City of Conway

PLANNING COMMISSION

May 18, 2020 · Agenda

CORRECTIONS NEEDED ON THE PLAT

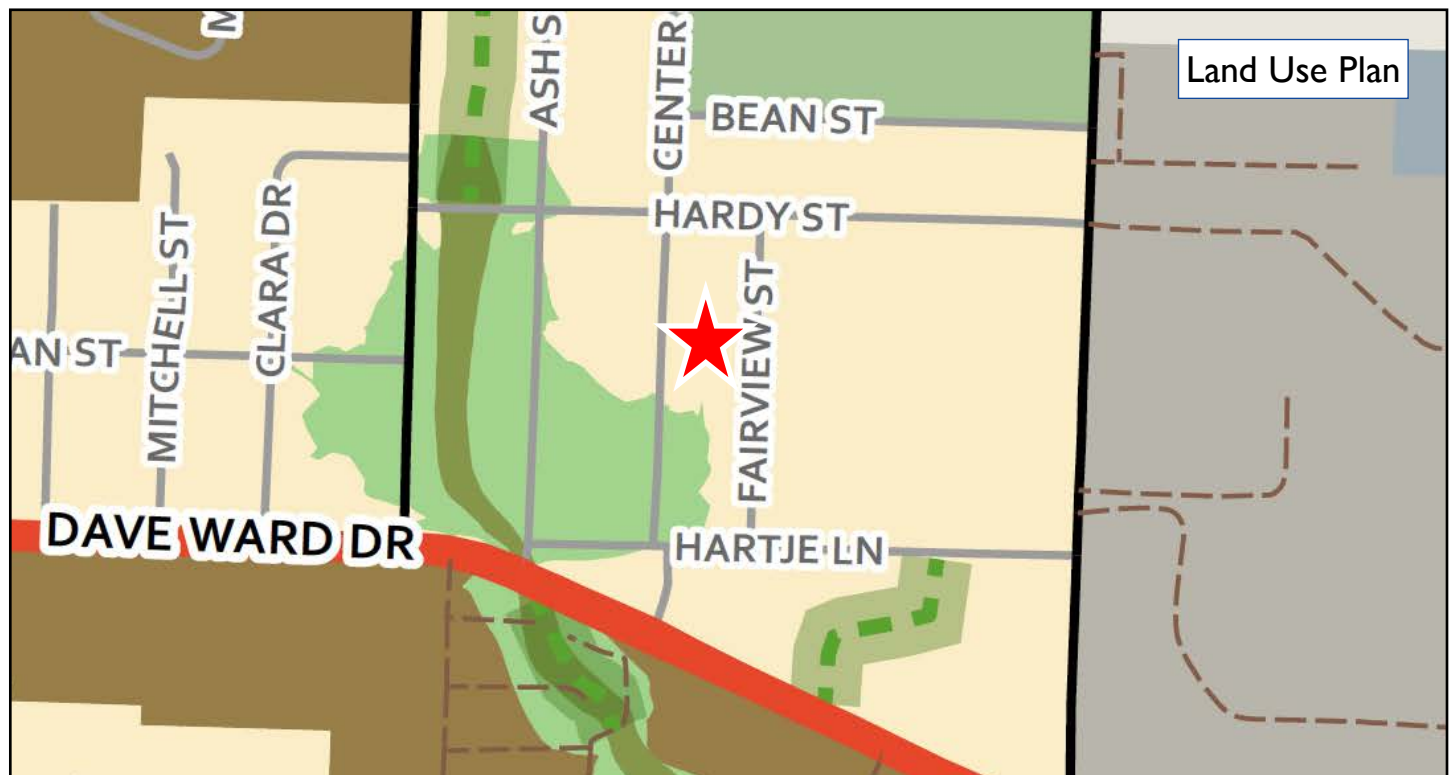
1. Show all hydrant locations.
2. Corrections as noted on Preliminary Plat.
3. A 5-foot right of way dedication for Fairview St shall be added to the plat.

CORRECTIONS NEEDED ON THE PLAT

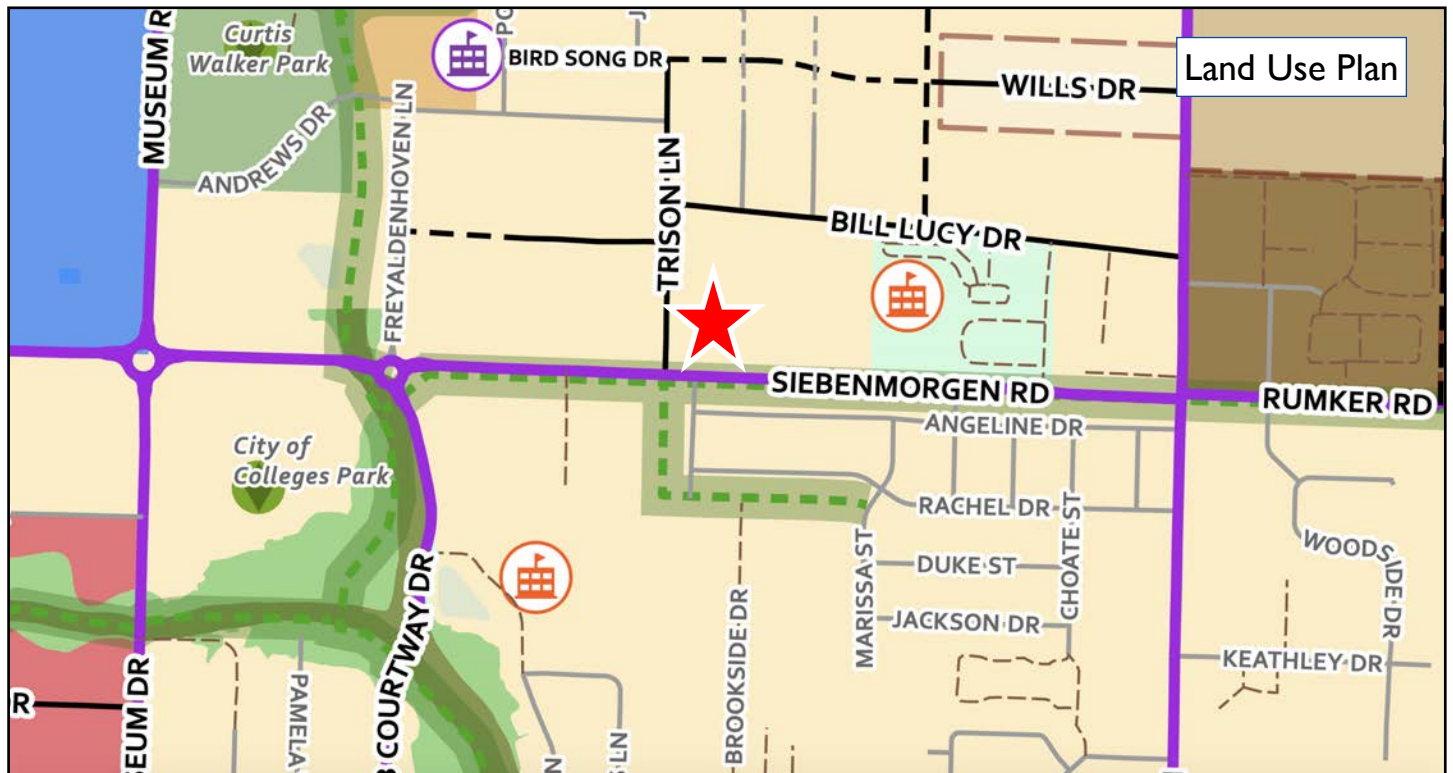
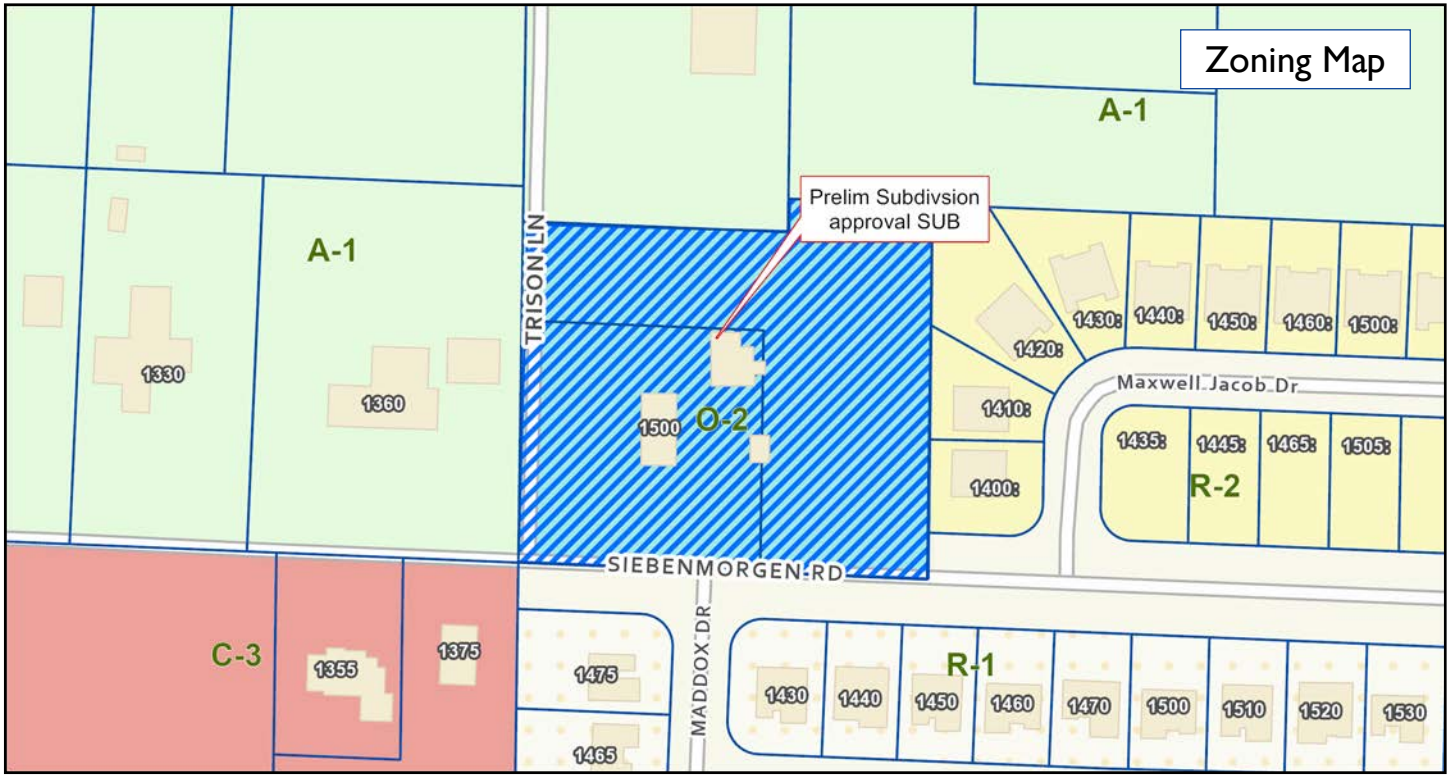
1. Show all hydrant locations.
2. Corrections as noted on Preliminary Plat.

1. Preliminary Plat approval from all reviewing agencies shall be obtained.
2. All setbacks shall be provided on the final plat, including the required 8-foot setback from the existing garage proposed to remain.

CORRECTIONS NEEDED ON THE PLAT

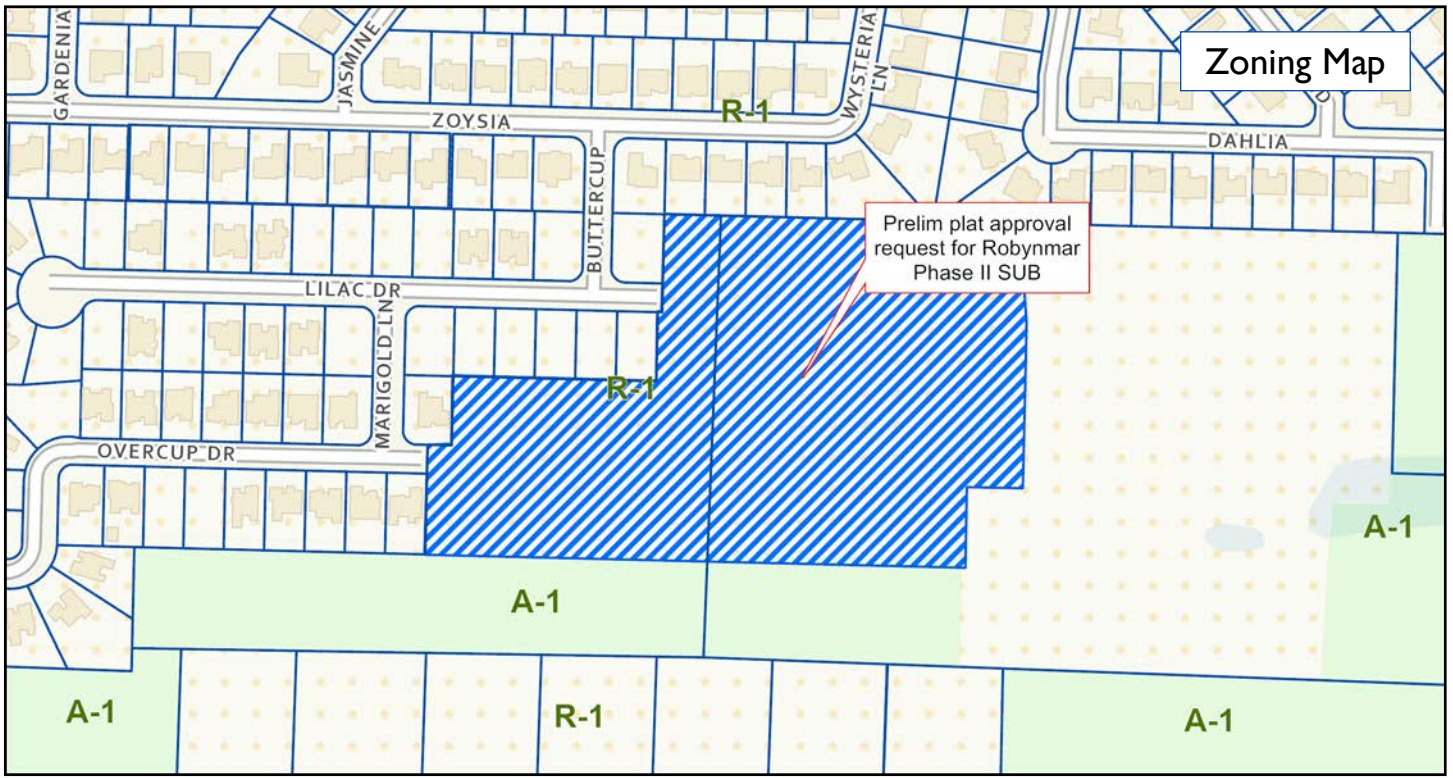
1. Show all hydrant locations.
2. Corrections as noted on Preliminary Plat.

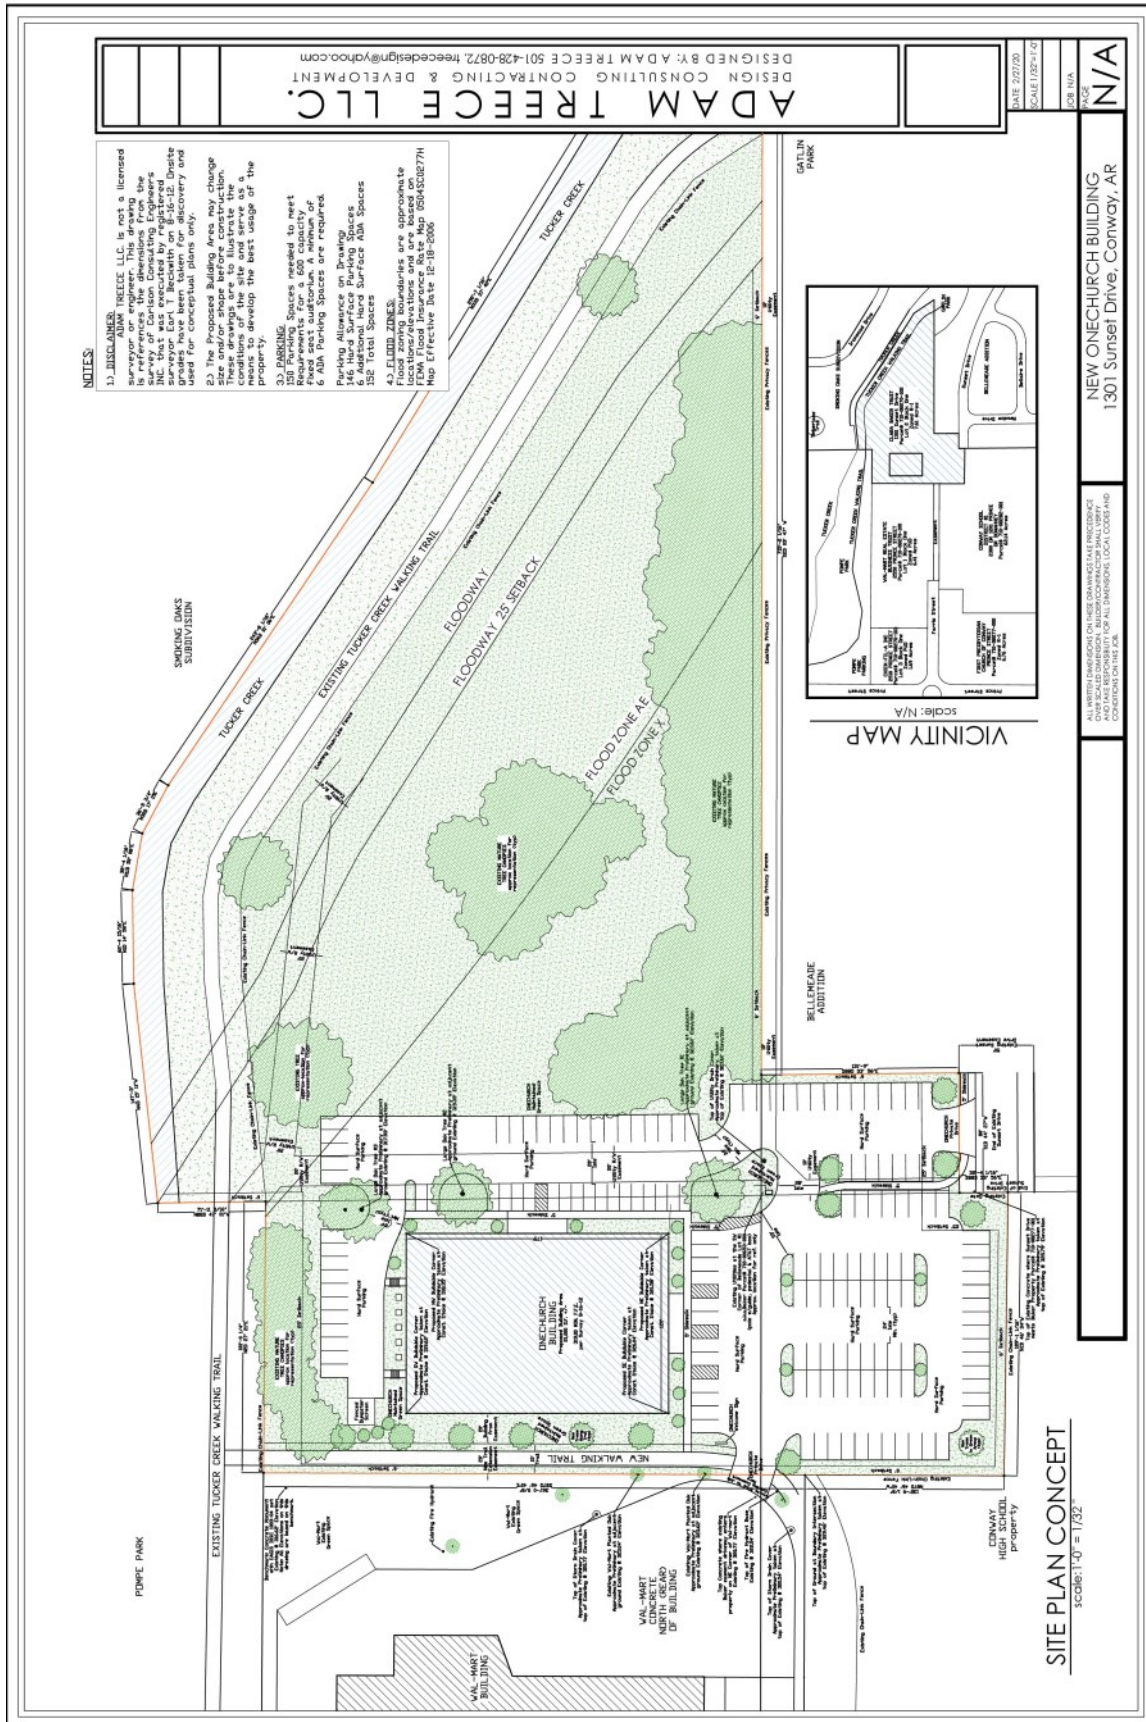
2. Parking area and dumpster enclosure shall be relocated to the interior of the site and screened from the existing trail.
3. Efforts shall be made to retain as much existing vegetation as possible.

6. A minimum 20-foot evergreen screen shall be provided along the northern property line abutting the residential property.
7. Trees planted 30 feet on center shall be provided in the landscape buffer on southern property line.

1600 PLACE P.U.D.

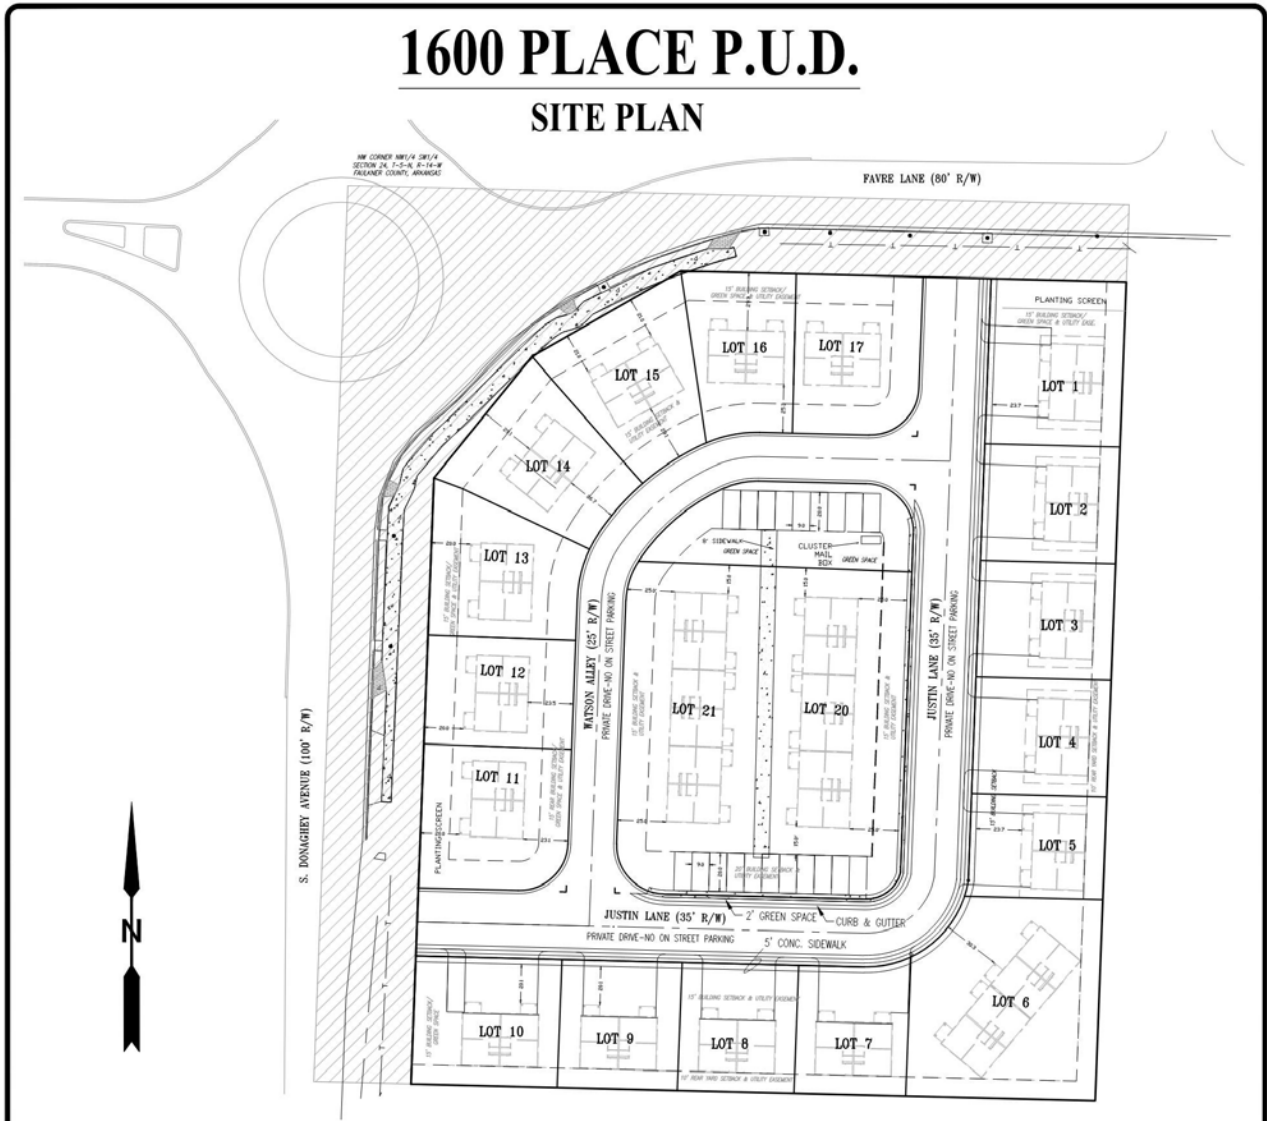
- All lot dimensions and proposed parking areas for all structures shall be included on the plan.
- Sidewalk extension is required to the property boundaries along S Donaghey Ave and Favre Ln; sidewalks are required along the south side of Lot 11 and the east side of Lot 17 pursuant to Section 9 of the Subdivision Regulations.

- The plan proposes setbacks as follows: 15' front and exterior, 10' rear; interior setbacks are not indicated, but are required to be indicated on the plan.
